SEWAGE DISPOSAL SYSTEM

HOWARD COUNTY HEALTH DEPARTMENT
BUREAU OF ENVIRONMENTAL HEALTH
410-313-2640

TO : Amy McMillen
FROM: Bruce Burton
DATE : December 27, 1999
RE : Brantwood 2/1 F99-140 Lot 5

Re: Brantwood lot 5

ALTERNATE WELL SITES

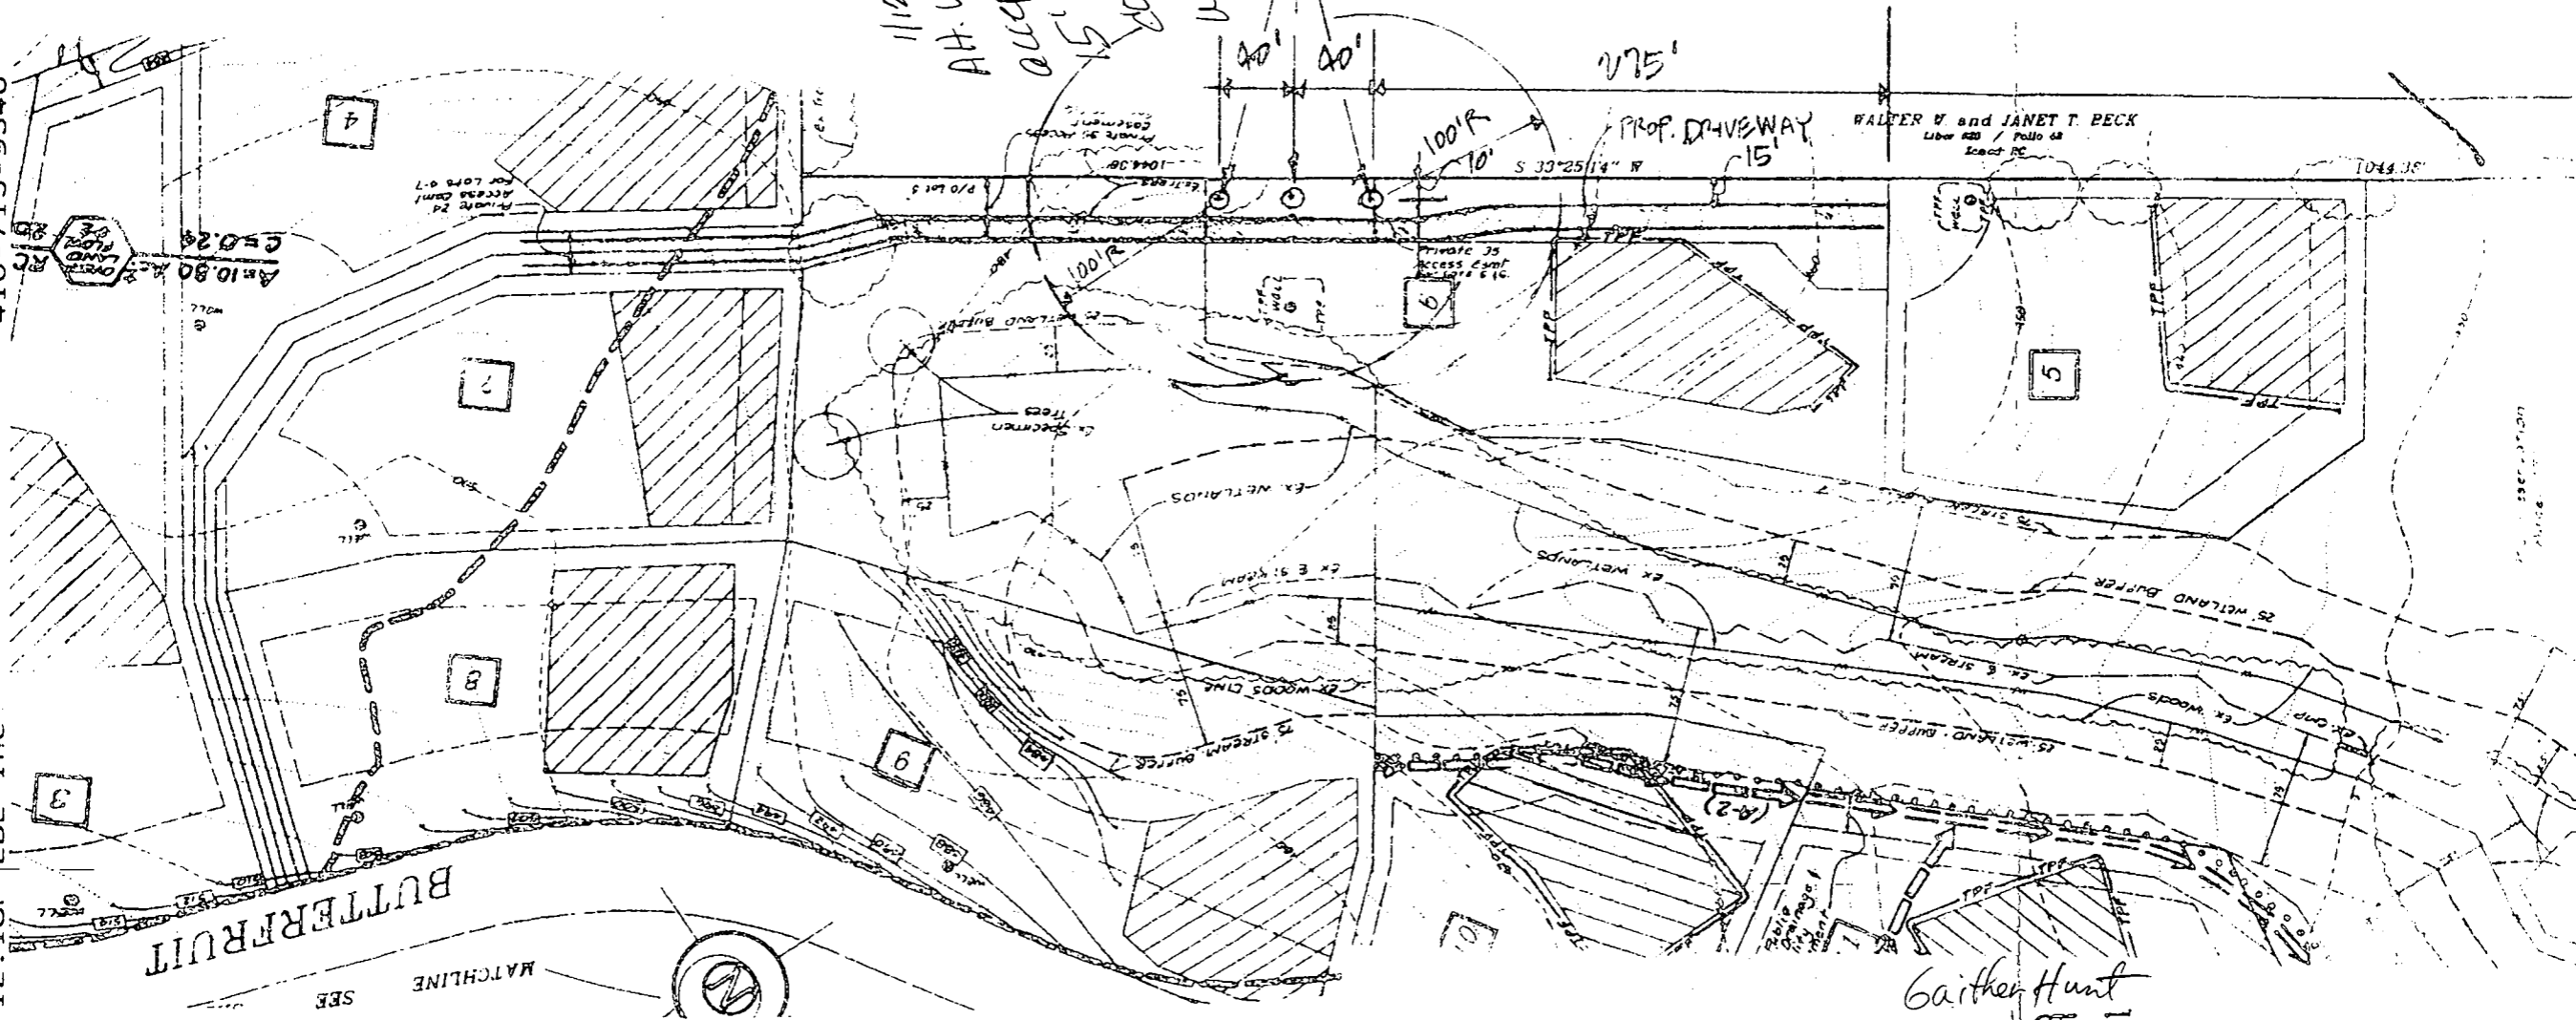
Please review and let me know if acceptable. If ok we will formalize our proposal to DPZ.

*1/11/00
 Sites accepted
 provided 15' well
 to use in common
 provided*

INTERMATE #3

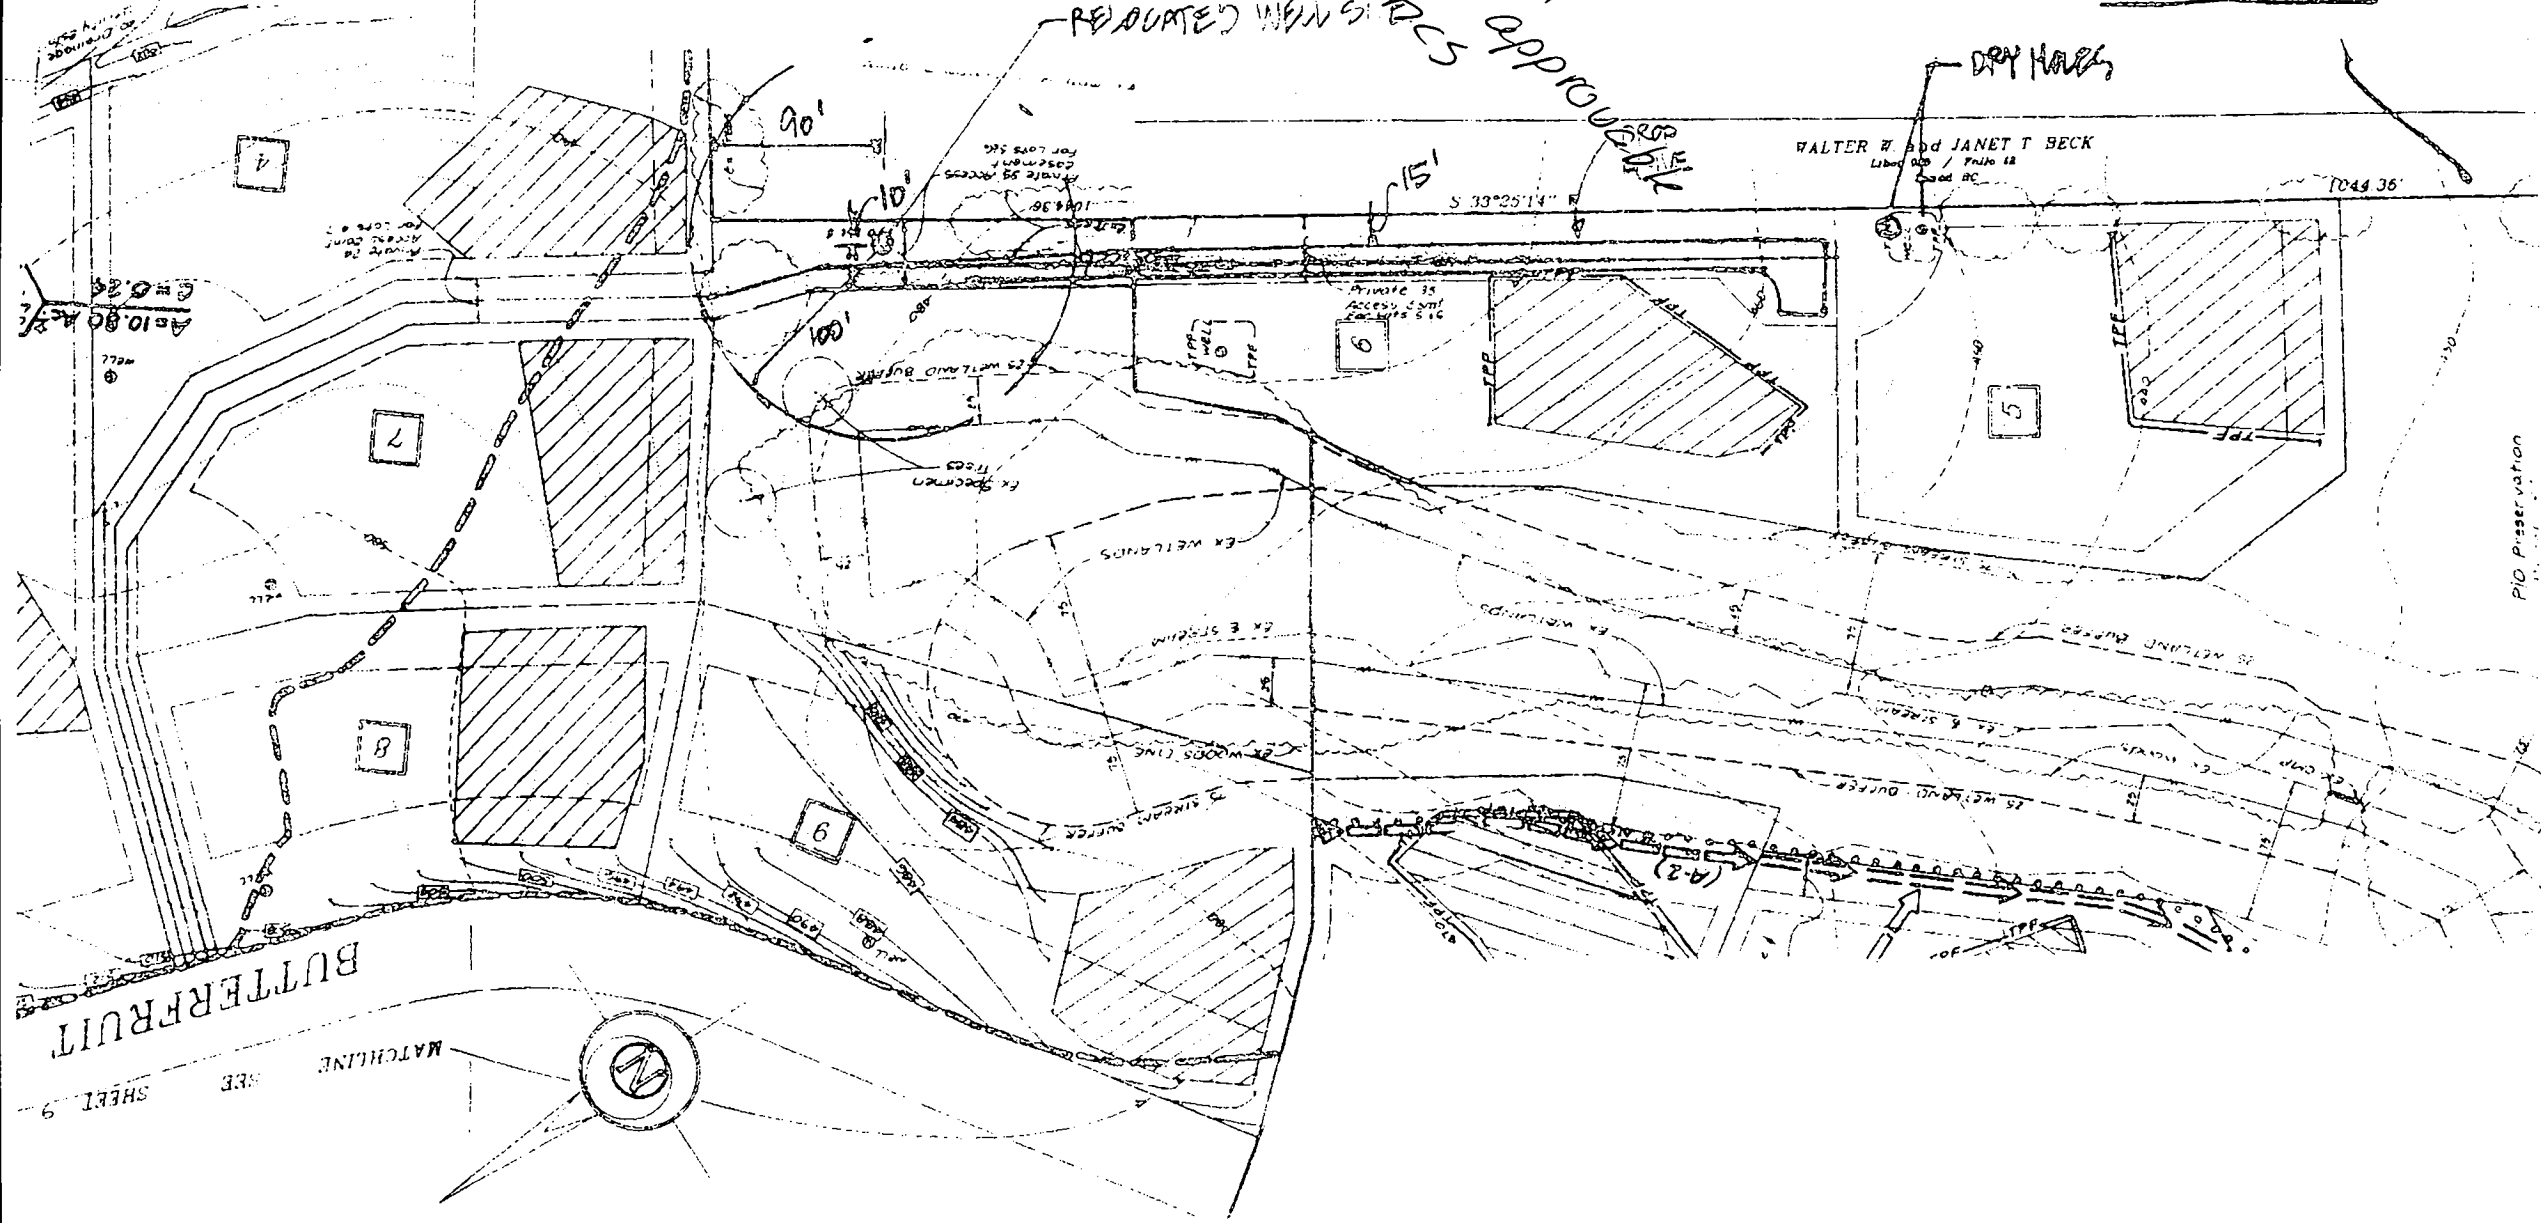
Alternate #2 slides the well laterally about 30' westerly. This alternate requires modification to the disposal area as shown. Does this alternate provide health compliance?

Alternate #3 relocates the well within the pipe stem for Lot 5. The stem will be enlarged to accommodate necessary minimum offsets from property/lot lines and the use-in-common driveway. Does this work?

1/4/99 well location not approved
Shows location due to setbacks
uphill on lots 4 & 7

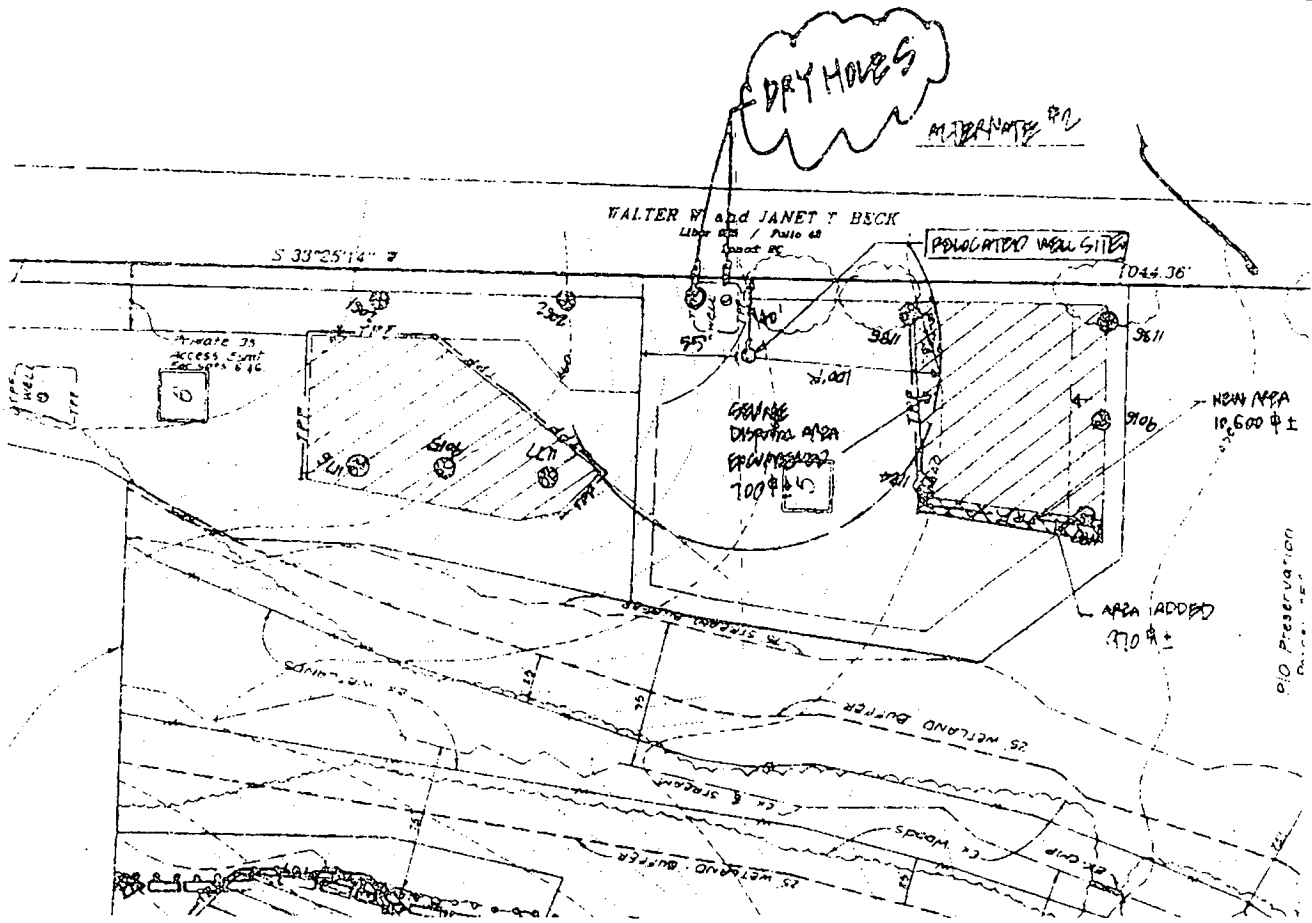
The area shown is not acceptable due to the presence of dry holes. A new area of 10,600 ± is needed for the SDA. This area is not acceptable due to the presence of dry holes.

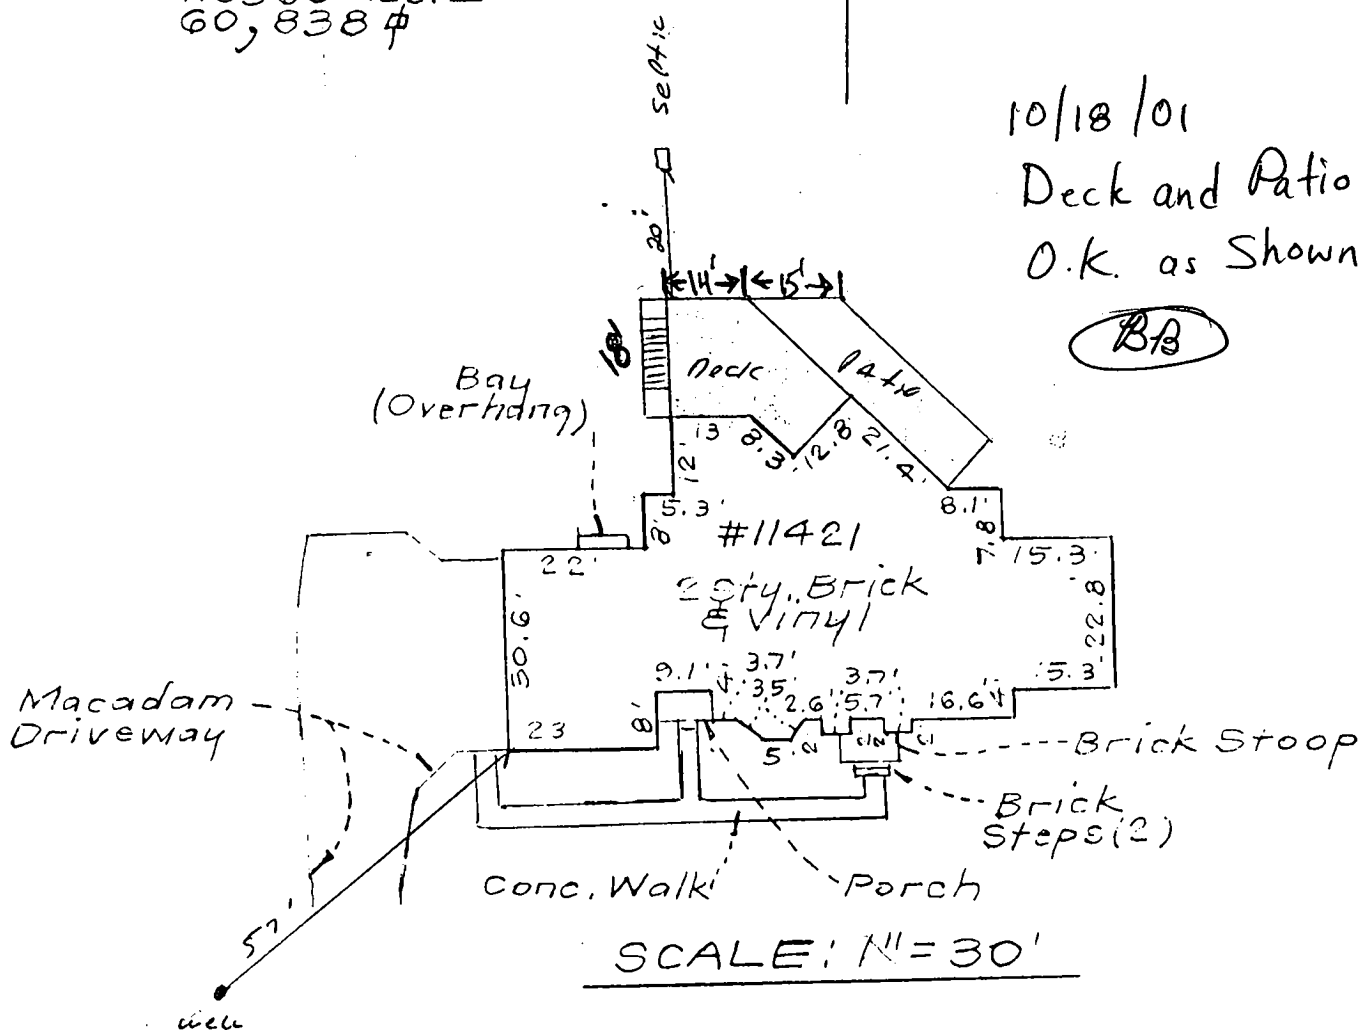
10/18/01
 Deck and Patio
 O.K. as Shown
